TRC AGENDA

**CITY OF DELAND
THURSDAY JULY 20, 2023 AT 1:30 P.M.
CITY OF DELAND TRC MEETING ROOM
DELAND, FLORIDA**

City of DeLand
SP23-097
COGGIN HYUNDAI

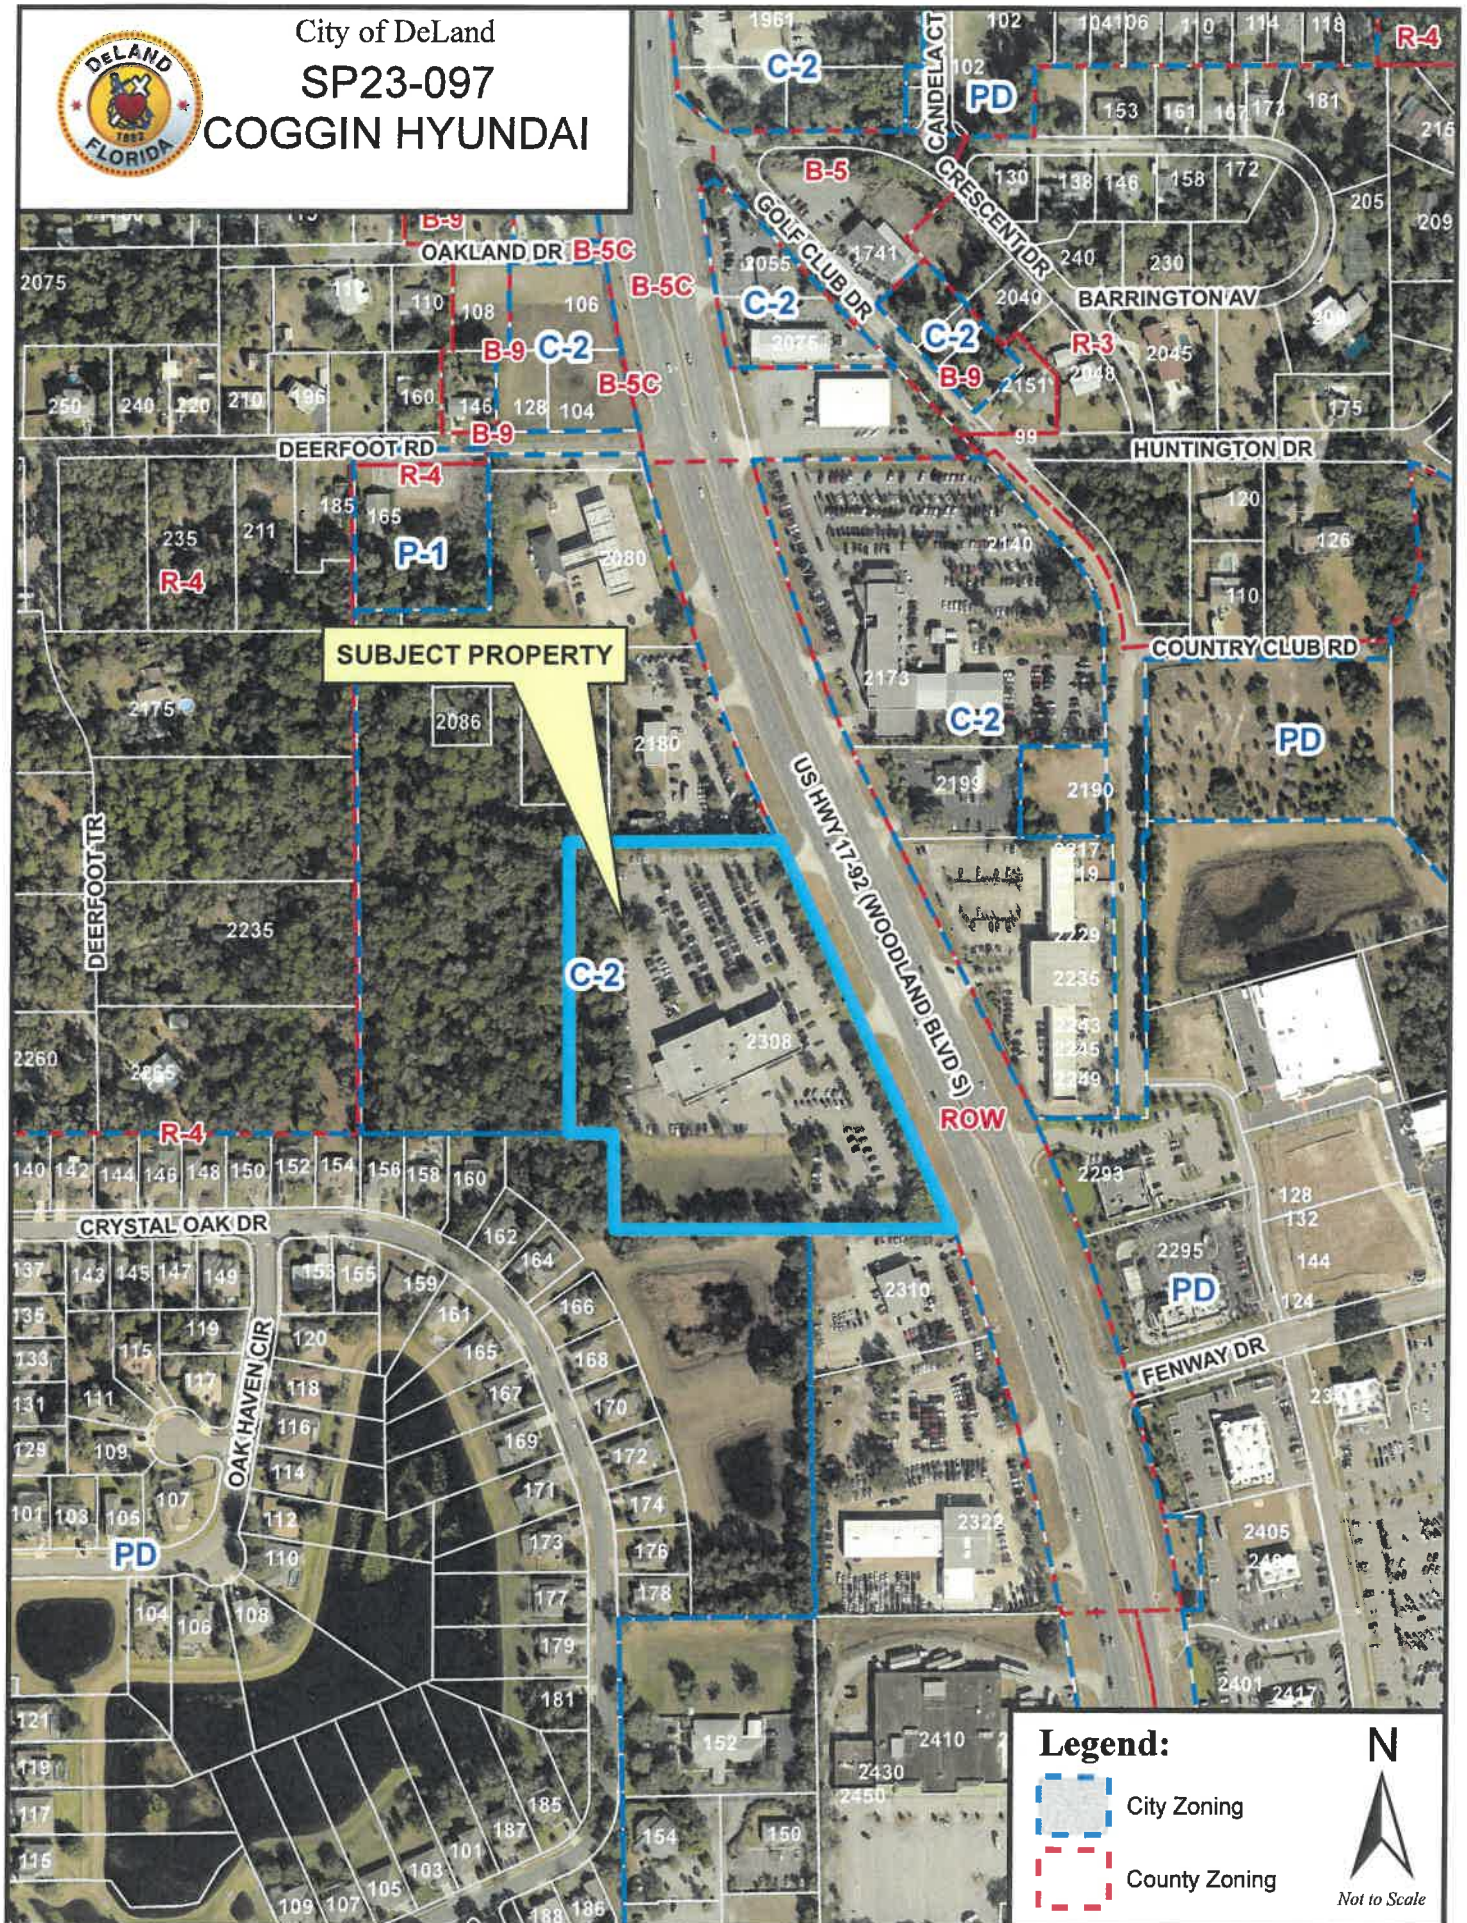
Discipline	Status	Details	Attached To	Created By	Last Updated By	Modifications Required
Spot Grade elevations adjacent to the building						
Engineering	Draft	Please check proposed spot grade elevations adjacent to the Northwest section of the building for positive drainage. It appears that stormwater runoff is going toward the building area (D-3 Elev. = 30.75', Adjacent building grades 30.19', 30.15', ...) In addition, proposed 24" RCP will connect to an existing 18" pipe. Has storm sewer design performed to make sure it is okay?	C5.1	Ray Bahrami	Ray Bahrami	Yes
Retaining Wall

1. It appears that proposed retaining walls will be designed by others. If that is the case, they need to be labelled on the plans. 2. There are multiple call-outs for Start Retaining Wall without any ending by the dumpster area. Last comment from reviewer: You may want to include a call out "Designed by Others". Last response: All retaining walls have been labeled. The structural plans for the wall around the dumpster will be included in a subsequent submittal. Top and bottom of wall elevations have been added to the plans.						
Engineering	Not Accepted		C5.1	Ray Bahrami	Ray Bahrami	Yes
Stop sign

1. Is there an existing stop sign and stop bar by exit to Woodland Blvd.?						
Engineering	Not Accepted		C4.1	Ray Bahrami	Ray Bahrami	Yes
Last comment from reviewer: Please change the spelling to Sign (It is spelled as Sing). Last response: There is an existing stop bar at the northern exit and a stop sign and stop bar at the southern exit to Woodland Blvd. Refer to the existing conditions sheets for locations.						
Forestry	Not Accepted		L1.51	Mariellen Calabro	Kit Dennis	Yes
Note O. 13. Removal of all sucker growth is not a recommended pruning practice. Limit sucker removal to the lower third of the trunk. Suckers in the branches should be removed,

Sheet Mislabeled						
Planning	Draft	This sheet is mislabeled as a Tree Protection Area Plan. Please revise to label it as a Site Plan.	C4.2	Melissa Winsett	Melissa Winsett	Yes
Planning	Draft	Recalculation Request	C4.3	Melissa Winsett	Deborah Click	Yes

Discipline	Status	Sheet	Attached To	Created By	Last Updated By	Modifications Required
Planning	Draft	Sheet is mislabeled as an Overall Paving, Grading and Drainage Plan. Please revise to label it as a Tree Protection Area Plan.	C4.3	Melissa Winsett	Melissa Winsett	Yes
Truck Loading/Unloading Area						
Planning	Draft	Please identify the location of truck loading/unloading area in the project area. Such area is located within the Vehicle Storage Lot.	C4.1	Melissa Winsett	Melissa Winsett	Yes
Identify Dashed Line						
Planning	Draft	Please label the dashed line located north of the driveway on sheet C4.1.	C4.1	Melissa Winsett	Deborah Glick	Yes
Landscape Buffer line						
Planning	Draft	Correct the Landscape Buffer dashed line to match that used on the plan.	C4.1	Melissa Winsett	Melissa Winsett	Yes
Detail						
Planning	Draft	Please provide a detail for all proposed fences and retaining walls including the proposed gravity wall adjacent to the compactor. Any fence, wall, or visual screen visible from public ROW shall be designed to match that of the principal structure. Please refer the Community Design Standards (33-94) (Fences, Walls, Screens and Landscape Buffers).	C4.1	Melissa Winsett	Melissa Winsett	Yes

Landscape Buffers						
Planning	Draft	Please show all Redevelopment Gateway Standard-required Landscape Buffers. If signage is being updated, please show all signage too.	C4.0	Melissa Winsett	Melissa Winsett	Yes
Pedestrian Access						
Planning	Draft	Please show all existing and proposed pedestrian accessways with dimensions including accessible routes to comply with the Florida Accessibility Code. Show how pedestrians will safely access the site from the Woodland Blvd sidewalks.	C4.0	Melissa Winsett	Melissa Winsett	Yes
Bicycle Parking						
Planning	Draft	Staff was unable to locate the required bicycle parking, number and placement of racks. Please identify location of bike parking if provided.	C4.0	Melissa Winsett	Deborah Glick	Yes
Project Area West Side						
Planning	Draft	A dashed "X" line is shown on the west side of the project area. This is typically a fence, but the plans cannot confirm this. Please include the dashed "X" line in the legend. Also, explain how this impacts the location of the large compactor since the dashed "X" line runs through it vertically.	C3.3	Melissa Winsett	Melissa Winsett	Yes

City of DeLand
SP23-098
GATOR'S DOCKSIDE

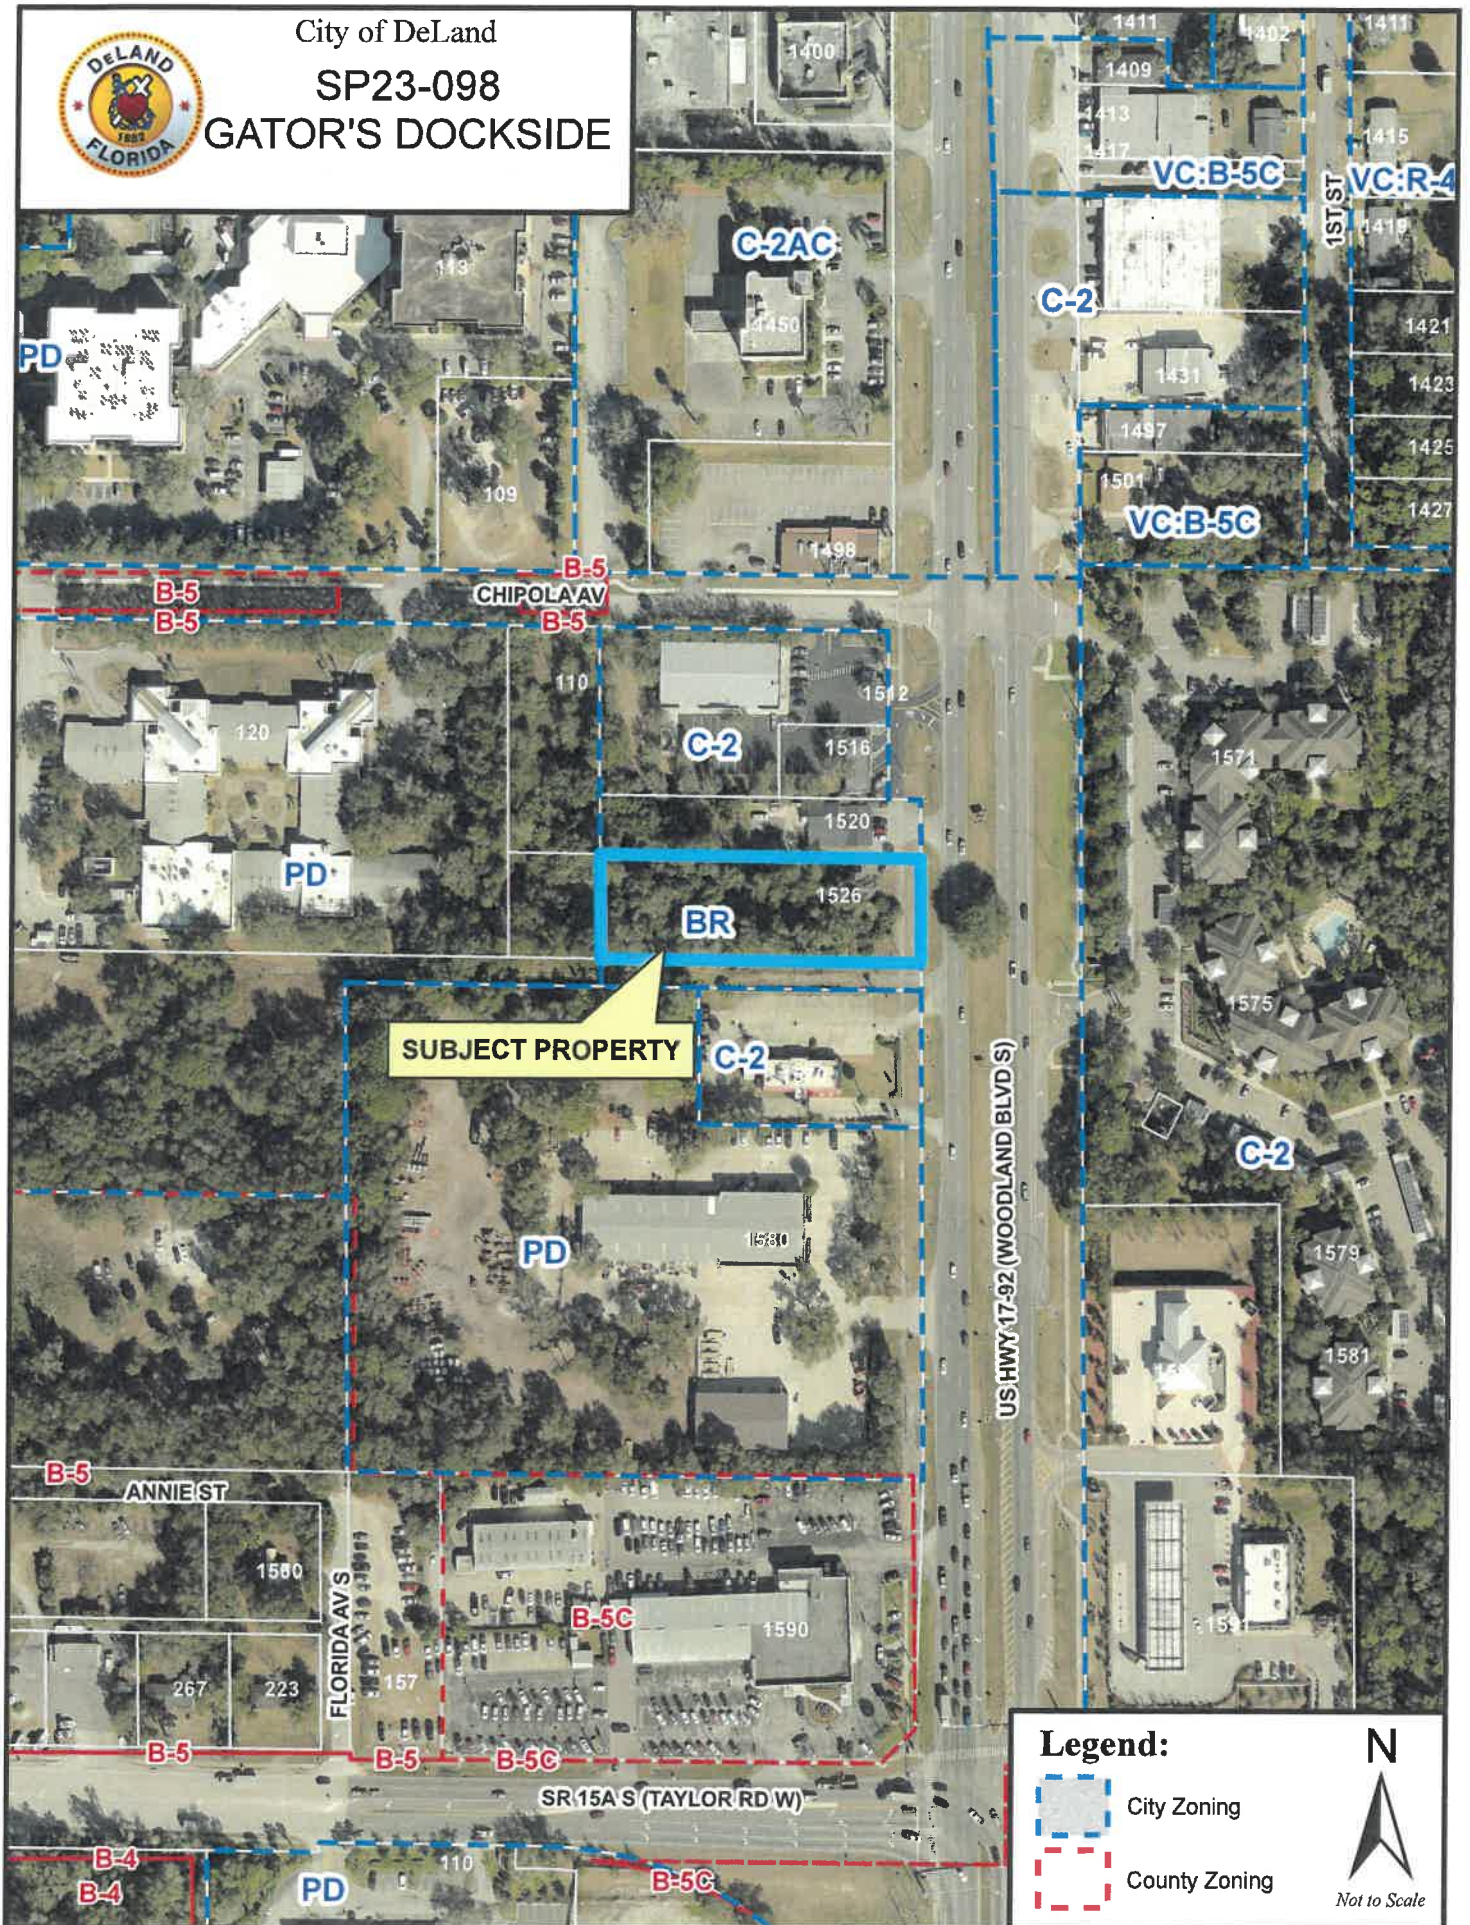
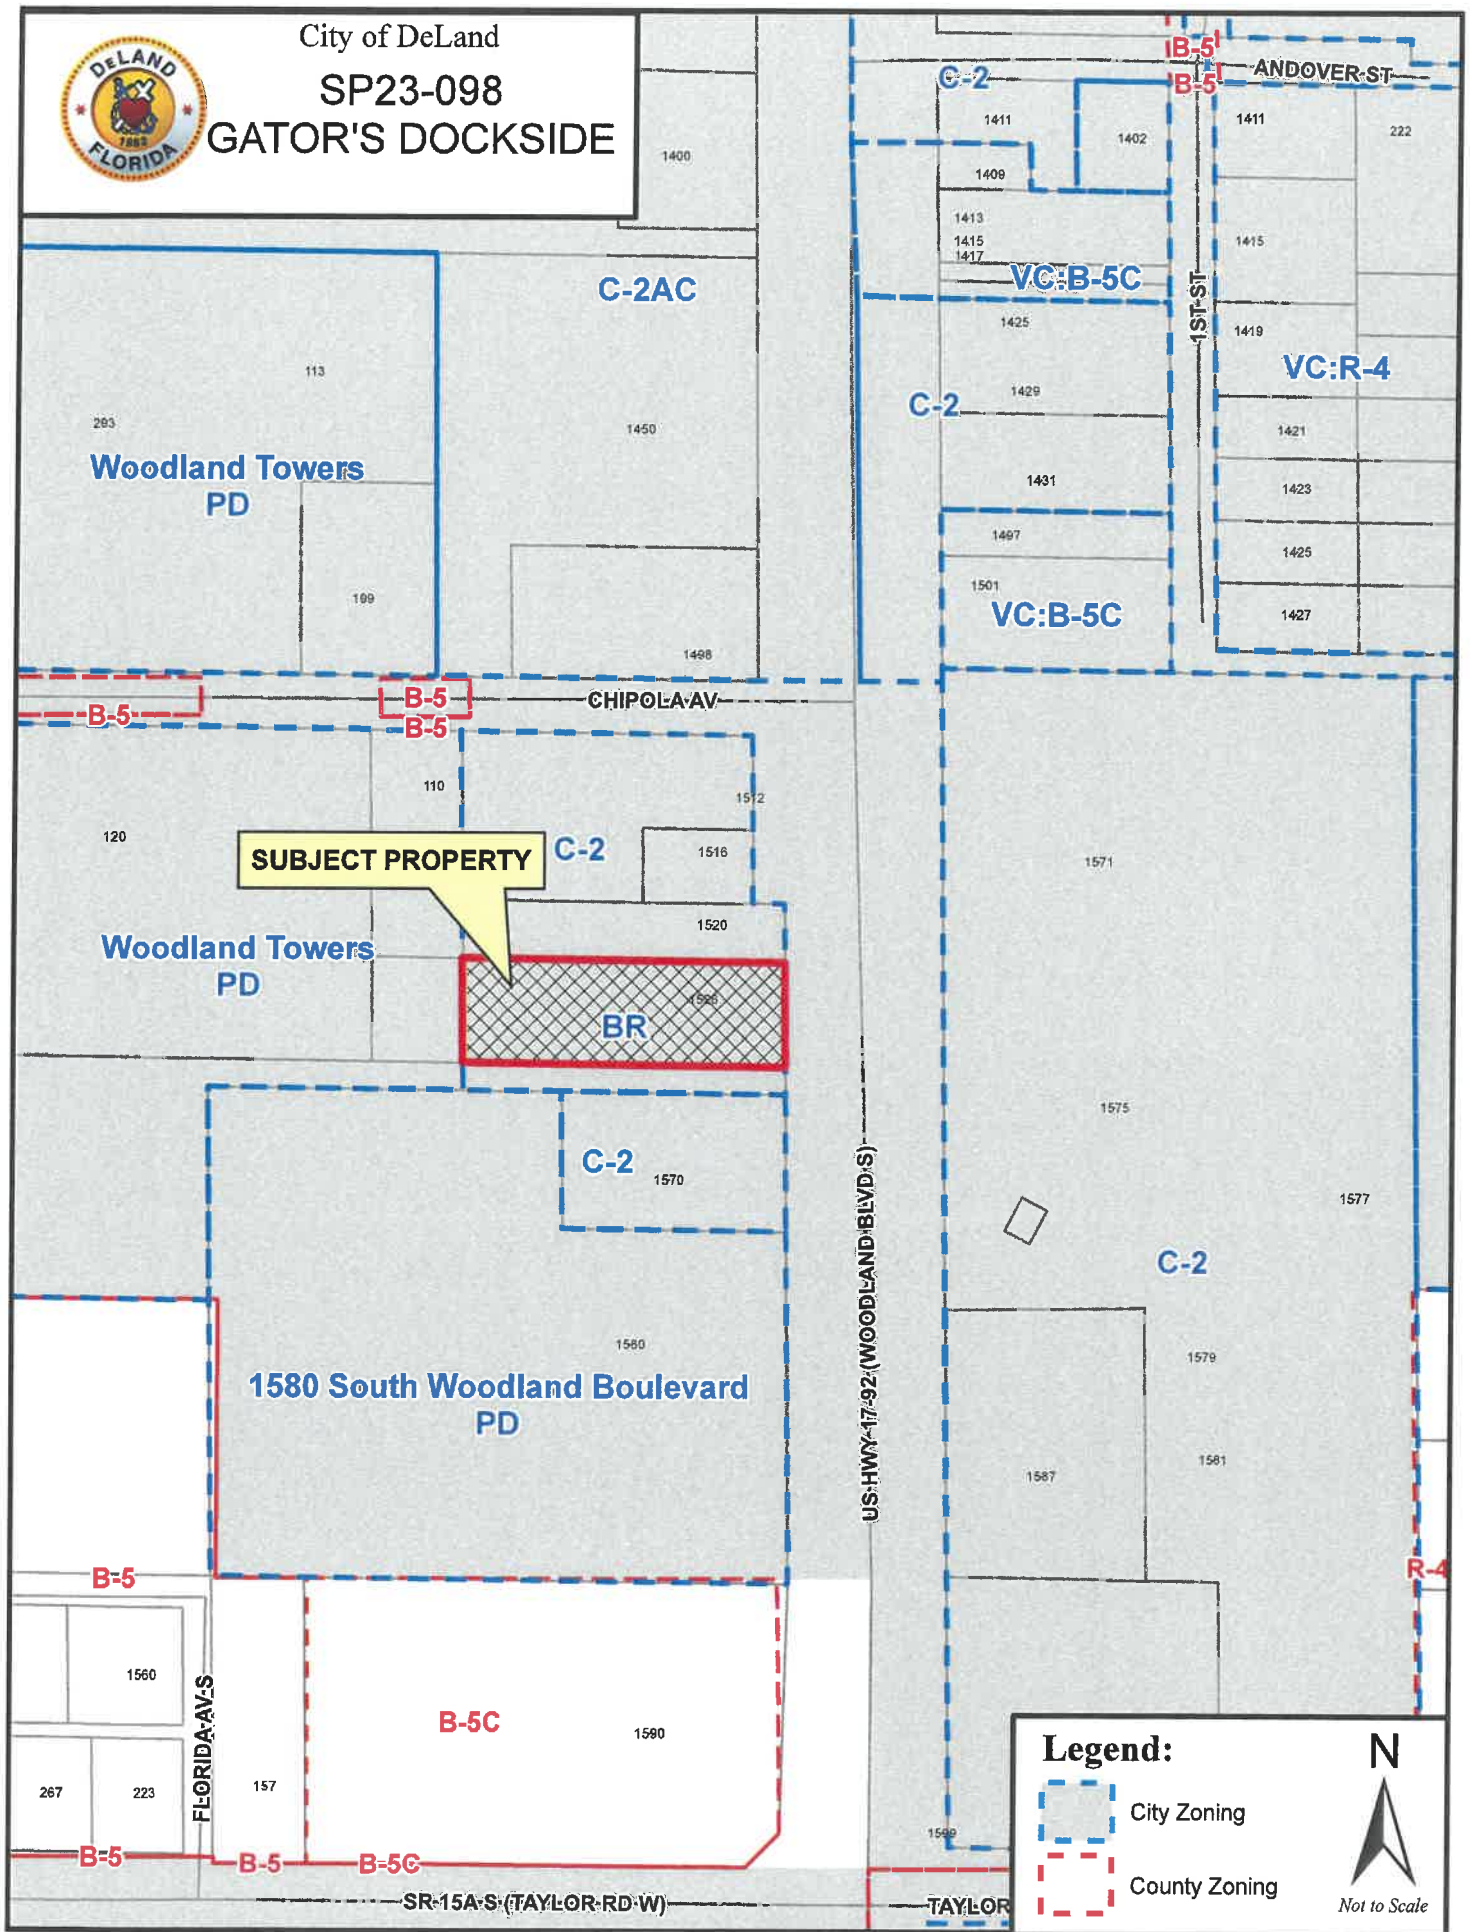
Discipline	Status	Details	Attached To	Created By	Last Updated By	Modifications Required
Tree Protection Area						
Clearly show the limits of the 15% Tree Protection Area. This area should be shaded and clearly labeled.						
Forestry	Not Accepted	Last comment from reviewer: It doesn't appear that your Tree Protection Area meets the minimum width requirements. Minimum width is 30' for protecting existing trees, and 20' for replacement trees. Please show the measurements of your Tree Protection Area on the plan.	L1	Mariellen Calabro	Kit Dennis	Yes
Last response: Tree preservation area has been added to the landscape plan.						
Quercus nigra						
Quercus nigra is not typically found in this area. The deciduous trees on the property are most likely Quercus laurifolia.						
Forestry	Not Accepted	Last comment from reviewer: Please make the corrections based on the site visit. The trees in question were determined to be Quercus laurifolia.	02	Mariellen Calabro	Kit Dennis	Yes

Last response: A site visit has been scheduled to determine the tree species.						
Tree Removal Calculations						
Change trunk diameter for 6" trees to 54". Change total inches removed to 487. Change total replacement required to 162". Change proposed inches to 34", and deficit to 128".						
Forestry	Not Accepted	Last comment from reviewer: If you have nine six-inch DBH trees, you would have 54" total trunk diameter. This will change your total, replacement, and deficit calculations.	L1	Mariellen Calabro	Mariellen Calabro	Yes
Last response: Tree removal calculations have been revised.						
Trees Removed and Preserved						
Forestry	Not Accepted	Please provide an excel spreadsheet showing trees removed and preserved.	L1	Mariellen Calabro	Kit Dennis	Yes

Mechanical Equipment						
Planning	Not Accepted	All rooftop mechanical equipment shall be screened. Show all rooftop mechanical equipment as dashed lines behind a screened wall. ***During the TRC meeting - it was determined that a small generator could encroach into the side setback (north side). Applicant stated that the generator would have a foot print of less than 3 feet in width and it would be properly screened." TRC found this to be acceptable. *** Last comment from reviewer: Please show the location of the mechanical equipment as dashed lines. Last response: Architectural plans have been revised to include a 48" high parapet which will provide screening for any proposed rooftop mechanical equipment.	06	Samuel Nelson	Samuel Nelson	Yes
Internal Landscaping Calculations						
Planning	Not Accepted	In the Redevelopment Overlay District, all nonresidential parking lots shall have internal landscaping equaling 10% of the total vehicle use area, including driveways, parking spaces, and vehicle storage and display areas. Where a pedestrian parking access pathway is required, the access pathway may be included in the required landscaping area. (33-36.05(b)2). Please show how this is being met. Last comment from reviewer: Please include calculations showing that the provided internal landscaping will equal 10% of the vehicle use area. Last response: Please see the hatch that has been added for the internal landscape area.	L1	Samuel Nelson	Samuel Nelson	Yes

Planning	Not Accepted	33-91.06. (b) Last comment from reviewer: Please show the 10' vehicle separation area and show that the vehicle overhang will not encroach. Last response: The parking spaces have been revised to keep the vehicles out of the 10' separation area. The spaces along the southern portion of the site are 17' in length to the curb face with an additional 2' accounting for overhang. The effective parking space length is 19' and does not encroach in the required 10' separation.	06	Samuel Nelson	Samuel Nelson	Yes
